Item 4 - Correspondence

CHEVY CHASE DR. -SKETCH PLAN # 320210010 & PRELIM PLAN # 120210010

Subject: 4702 Chevy Chase Drive - Residential comments for the record

TREE BUFFER ON NOTTINGHAM ROAD TO BE DESTROYED BY DUPLICATE SIDEWALK TO NORWOOD PARK

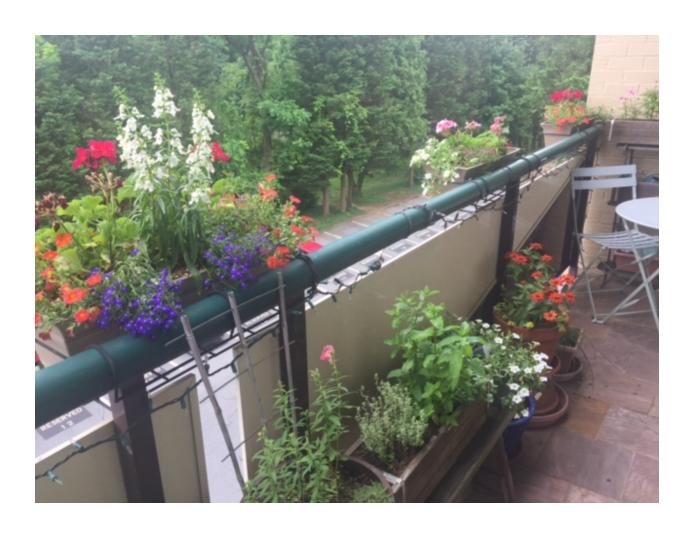
(PHOTOS FROM THE REAR BALCONY OF A UNIT IN THE BUILDING-SUMMER 2019)
